ADDENDUM NO. 04

August 19, 2026

Oak Hill United School Corporation – Multi-School MEP Improvements
405 South Washington St, Swayzee, IN 46986
7760 Delphi Pike, Converse, IN 46919
600 Walnut St, Converse, IN 46919

Addendum Four (AD.04) to the drawings and specifications prepared by Gibraltar Design for **Mechanical Improvements Across Three Schools** for Oak Hill United School Corporation Converse, Indiana.

© GIBRALTAR
DESIGN SHEET
G-101

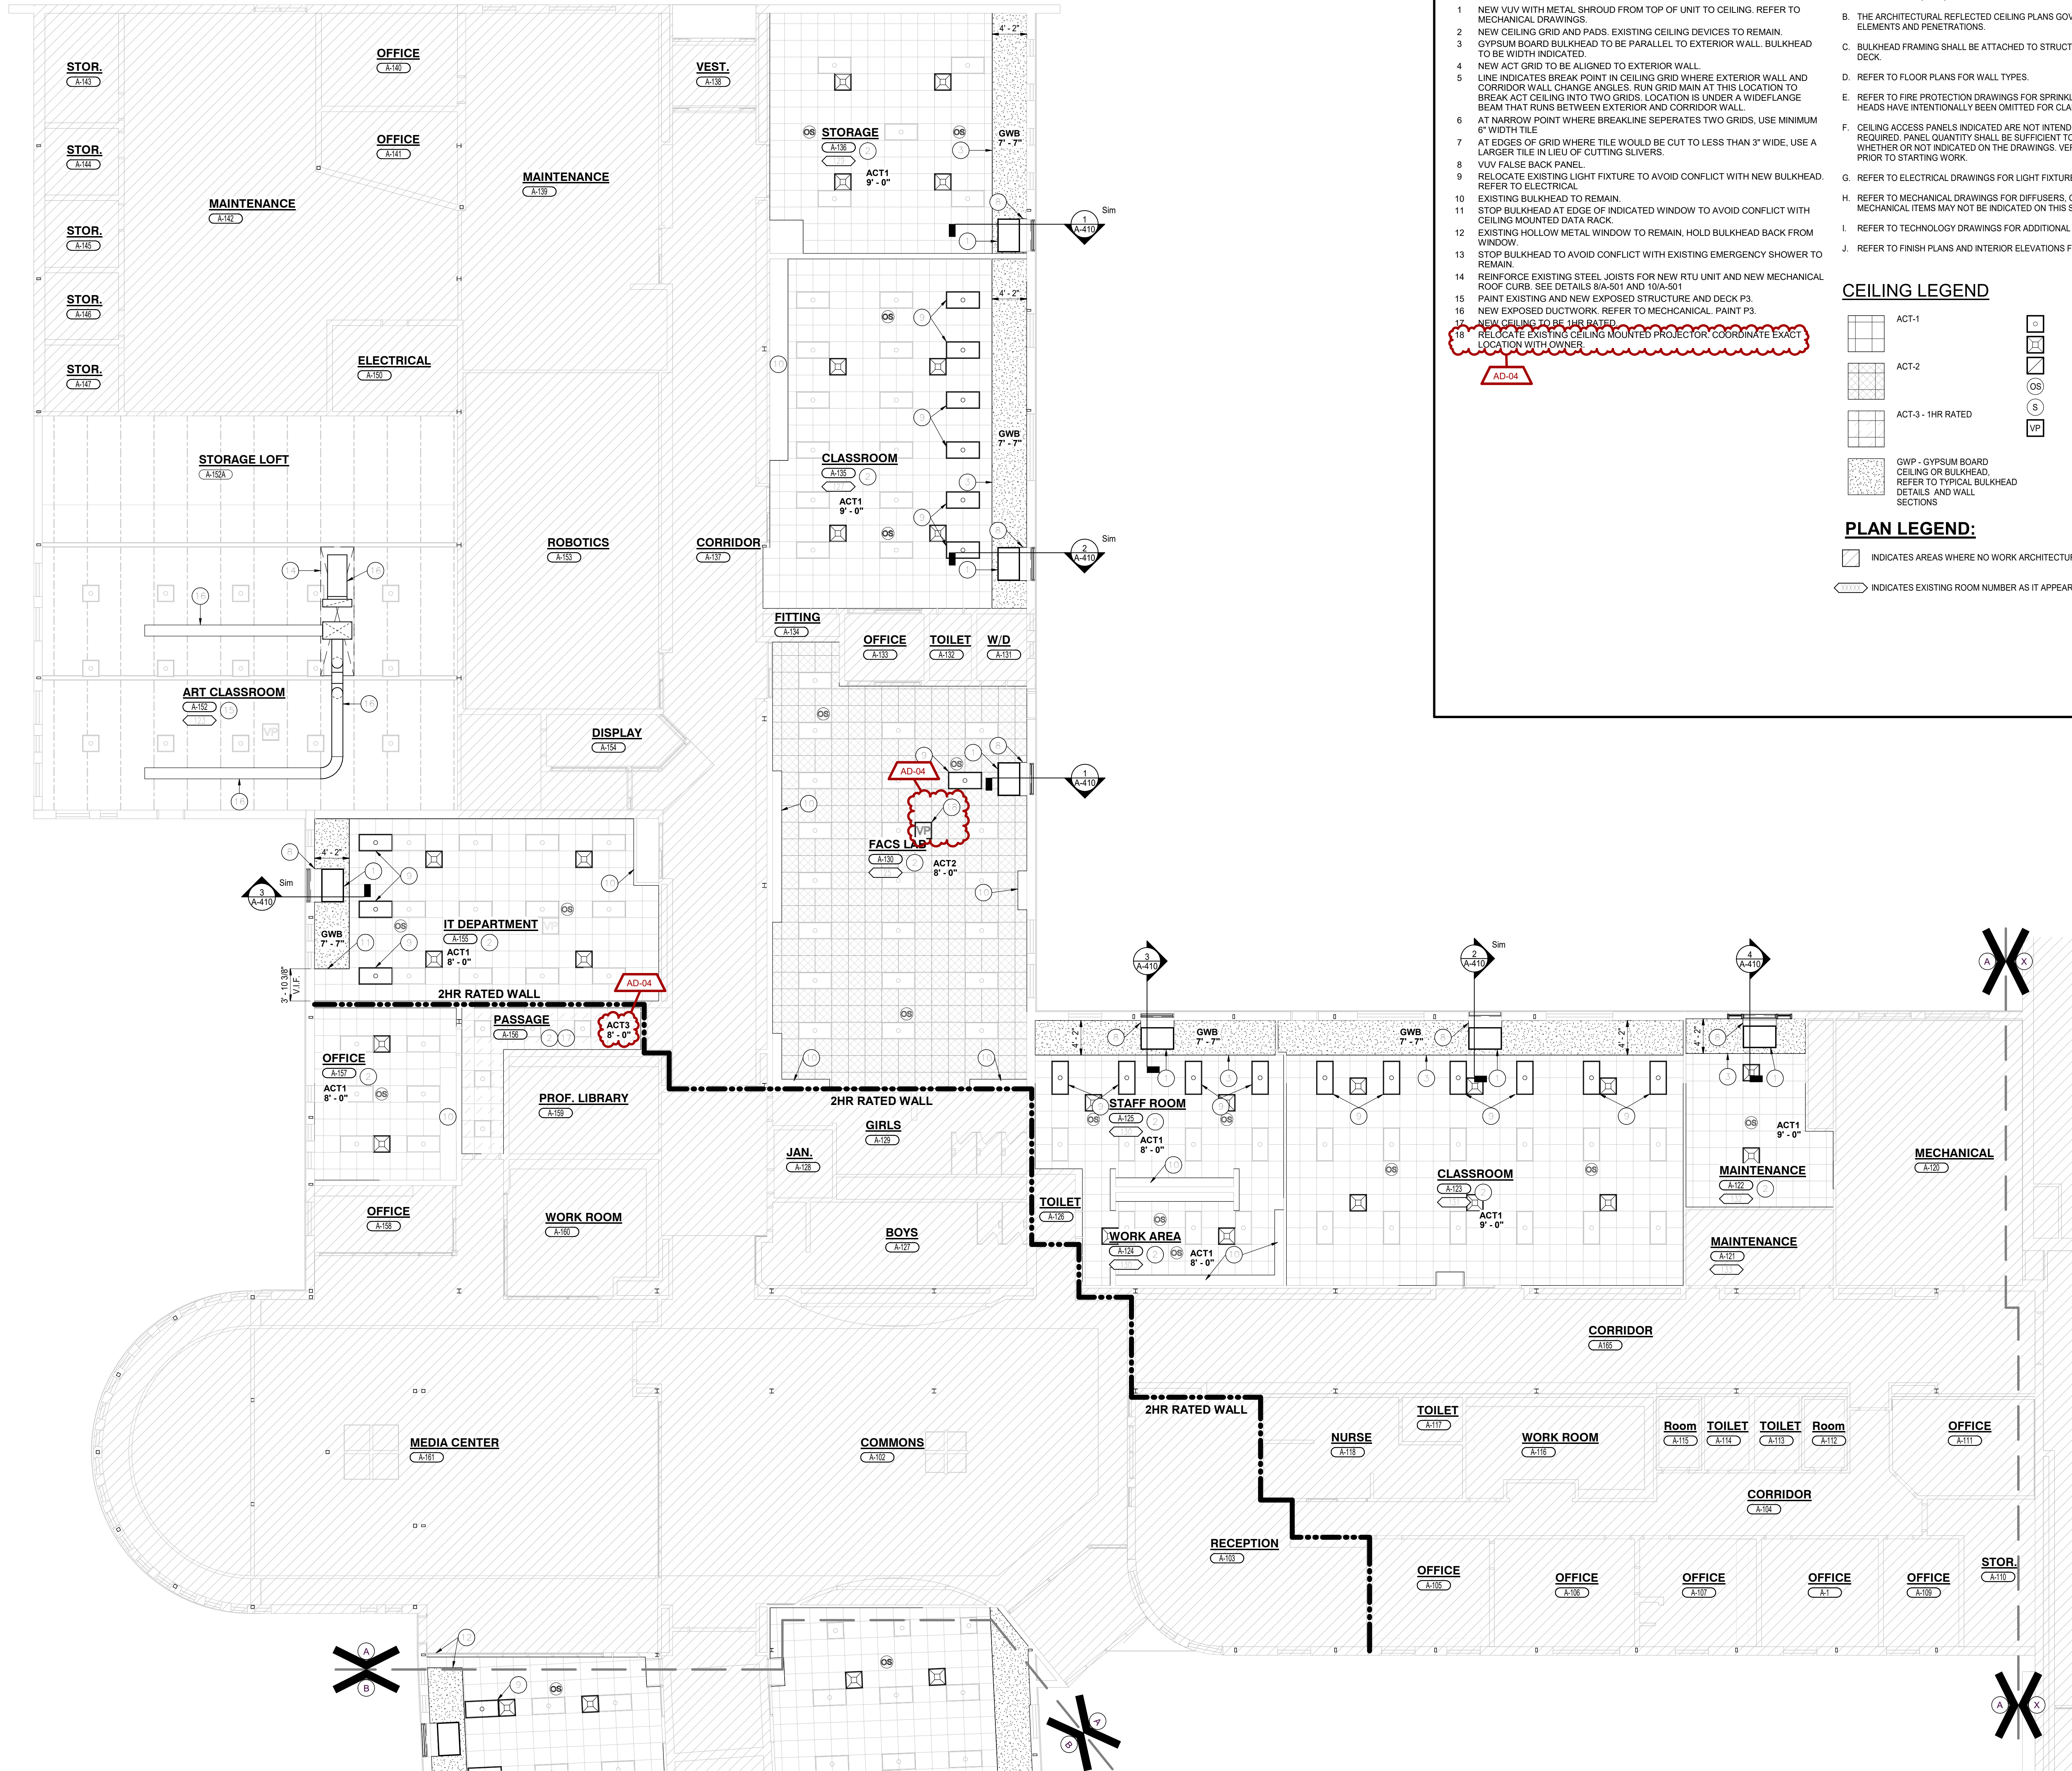
OAK HILL JUNIOR HIGH SCHOOL**3. Sheet G-101**

- A. Refer to revised, full-size drawing, included in this Addendum, for revisions.

E-601

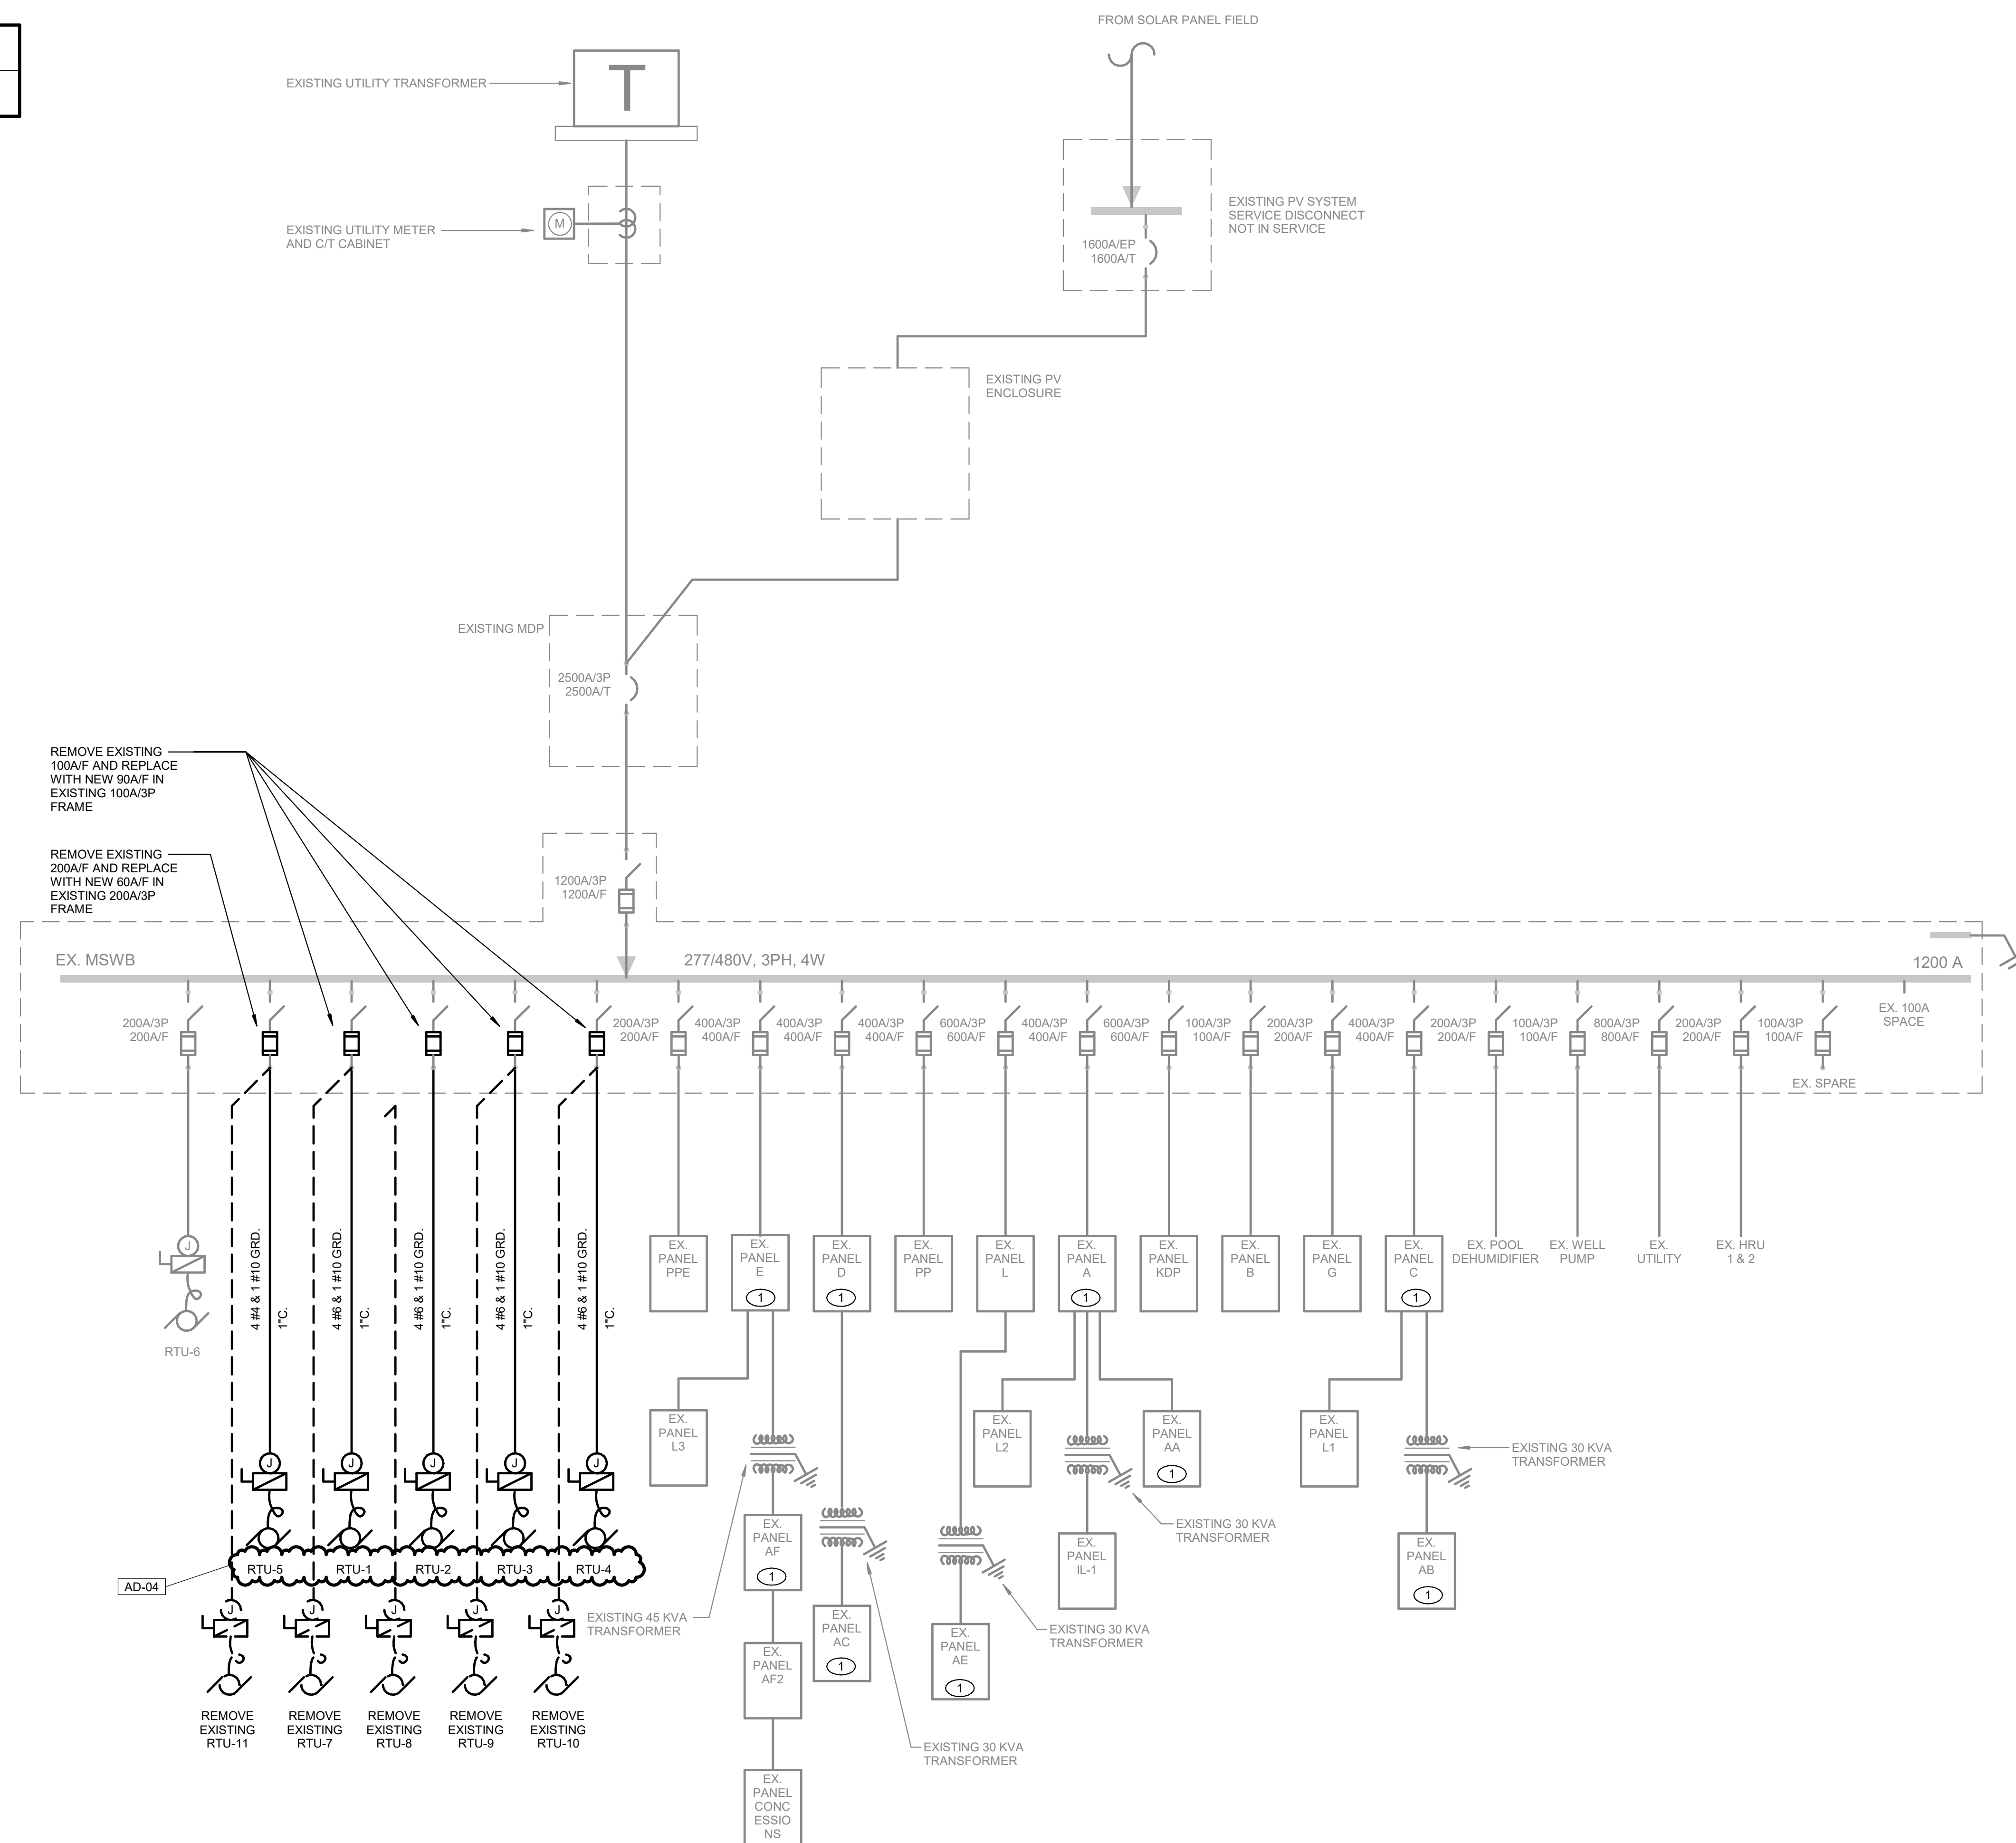
8. Sheet E-601

- A. Refer to revised, full-size drawing, included in this Addendum, for revisions.
